DEVELOPMENT APPLICATION

Primary Property	1 Ray Street, Turramurra
Lot & DP	Lot 1 DP221290, Lot 2 DP221290, Lot 1 DP 519532
Proposal	Demolition of existing supermarket and construction of a new supermarket, associated site works, car parking and signage
Development application no.	DA0133/13
Ward	Comenarra
Applicant	Coles Group Property Developments Ltd
Owner	Coles Group Property Developments Ltd
Date lodged	24 April 2013
Issues	Owner's consent, inadequate information, urban design, DCP compliance
Submissions	Yes
Land & Environment Court	N/A
Recommendation	Refusal
Assessment Officer	Adam Richardson

Figure 1B.4-1:
Built form plan

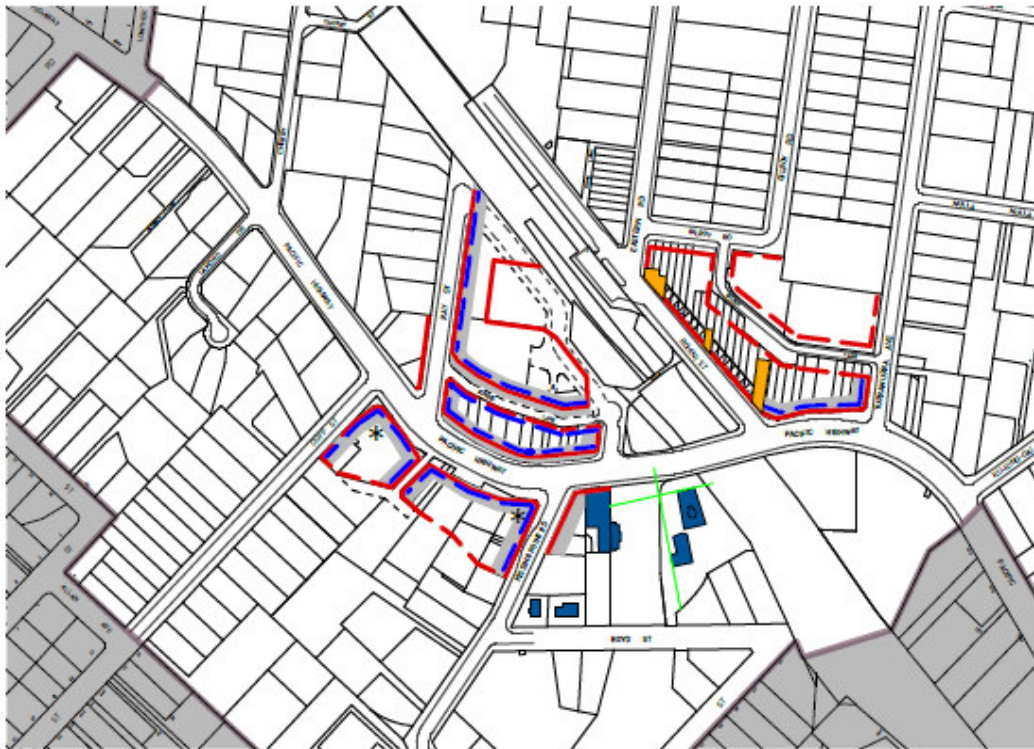
The built form controls requires Coles' to develop its site with due regard to surrounding land holdings.

Figure 1B.5-1:
Public domain and pedestrian access plan.

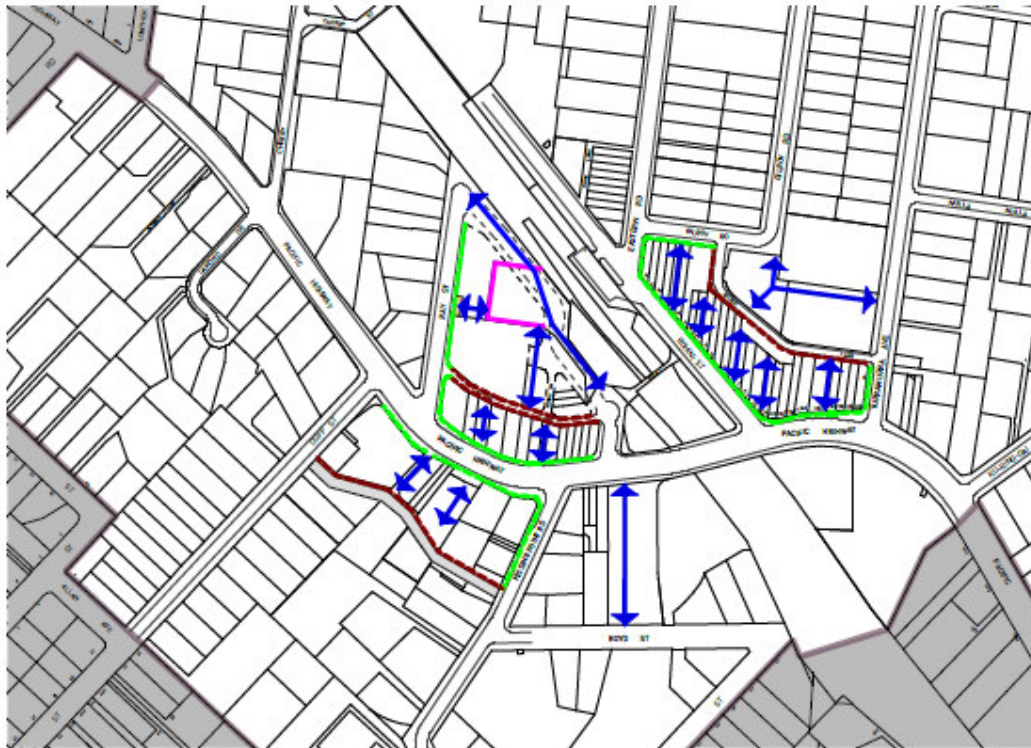
The proposed configuration is undesirable due to conflict with vehicular traffic and in the event of redevelopment envisaged by the DCP, would also be diminished as the town square and closure of William Street would provide a safer environment and legibility of access.

The current design is not appropriately resolved and is clearly conflict with the controls of the DCP.
